# Access Compliance Report

## Public Rights-of-Way

Intersection ID: 5600	Main Street: N_TRYON_ST	Cross Street: J_M_KEYNES_DR	Location: E
ADA ID: C45F604339A6	Ramp Type: Perp	Initial Pass/Fail: Fail	Overall Compliance: No
		Severity Score: 10

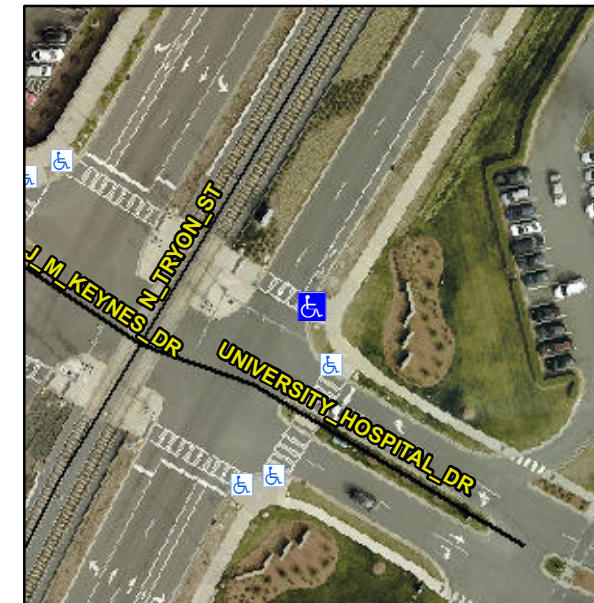
**R304.5.1, R304.5.3**

Compliance	Description	Data	Compliance	Description	Data
N/A	Ramp Length (in)	97.0	Yes	Ramp Slope (%)	5.3
No	Ramp Width (in)	47.5	No	Ramp XSlope (%)	3.0
N/A	Flare Type LT	N/A	N/A	Flare Type RT	N/A
N/A	Flare Slope LT (%)	N/A	N/A	Flare Slope RT (%)	N/A
N/A	Flare Traversable LT?	N/A	N/A	Flare Traversable RT?	N/A
N/A	Landing Length (in)	N/A	N/A	DWS Provided?	N/A
N/A	Landing Width (in)	N/A	N/A	DWS Contrast?	N/A
N/A	Landing Slope (%)	N/A	N/A	DWS Length (in)	N/A
N/A	Landing X Slope (%)	N/A	N/A	DWS Full Width?	N/A
N/A	Landing Curb? (Y/N)	N/A	N/A	DWS Offset (in)	N/A
N/A	Shared Landing?	N/A			
N/A	Gutter Ponding?	N/A	N/A	Gutter Slope (%)	N/A
N/A	Gutter Lip Ht (in)	2.0	N/A	Gutter X Slope (%)	N/A
N/A	Painted X Walk1?	Yes	N/A	Painted X Walk2?	N/A
	X Walk 1 Direction	To NW		X Walk 2 Direction	N/A
N/A	X Walk 1 Width (in)	118.0	N/A	X Walk 2 Width (in)	N/A
	X Walk 1 Slope (%)	1.6		X Walk 2 Slope (%)	N/A
	X Walk 1 X Slope (%)	0.5		X Walk 2 X Slope (%)	N/A

**Remove & Replace Entire Ramp.**
